July 11, 2017
Medway Planning and Economic Development Board
155 Village Street
Medway, MA 02053

Public Hearing Continuation - Merrimack Building Supply:

Public Hearing Continuation - O’Brien and Sons - Site Plan and Groundwater Protection Special Permit:

Public Hearing - Paul Revere Estates Definitive Subdivision Plan

LAYOUT & MATERIALS PLAN
O'BRIEN & SONS CORPORATE OFFICES

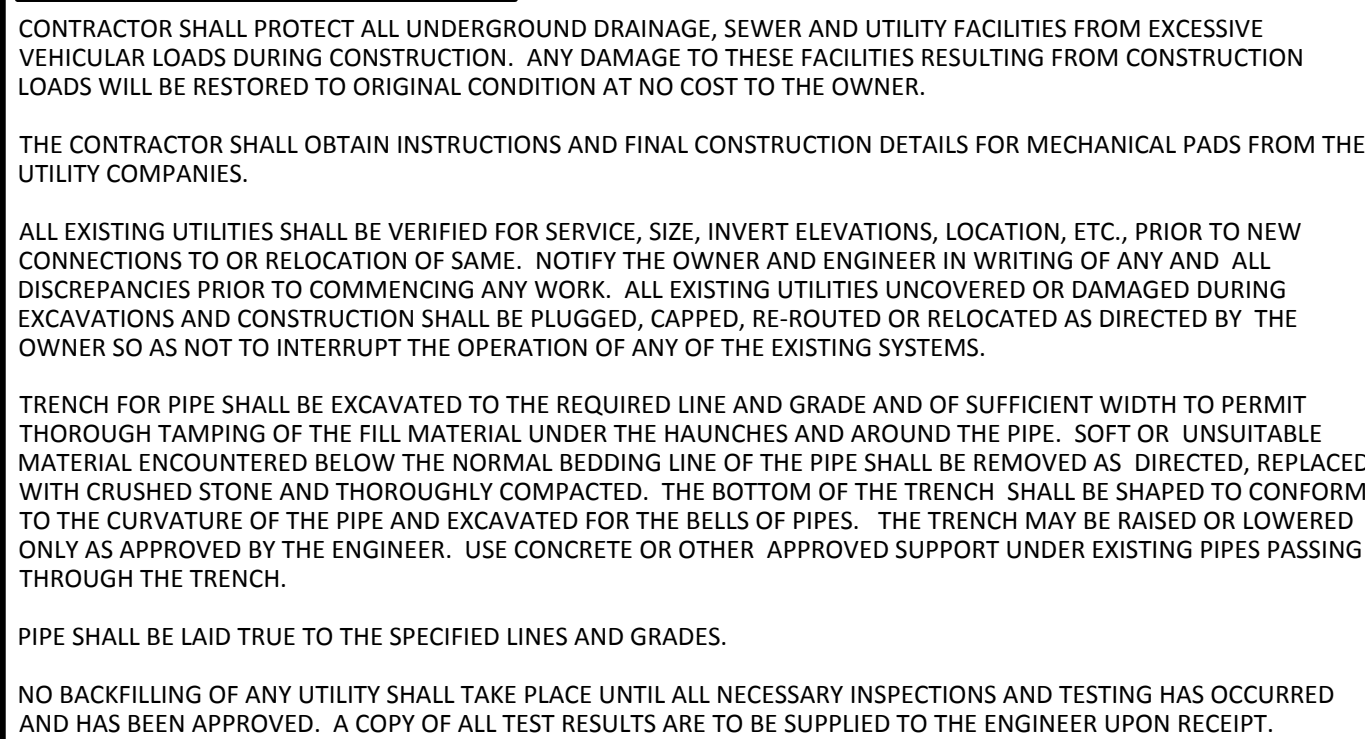
- 6) The plans do not show proposed curb radii or traffic pattern markings for parking areas. (Ch. 200 §204-5.D.2)
 - *MAI 6/13/17 Response: Proposed curb radii and traffic pattern markings, where appropriate, will be added to the Layout & Materials Plan (sheet C-2)*

- 5) We concur with the PGC Associates statement and no response required.
- 6) Proposed dimensions of proposed improvements (curb radii, travel widths, traffic pattern markings, etc.) will be added to the Layout & Materials Plan (sheet C-2).

- 16) Vertical granite curb is also proposed at the main entrance and will be clearly labeled on the Layout & Materials Plan (sheet C-2). Vertical precast curbing is proposed elsewhere on the site.
- 17) It is the opinion of our Landscape Architect that the four proposed trees provide shade to the parking or loading areas and meets the intent of the regulation.
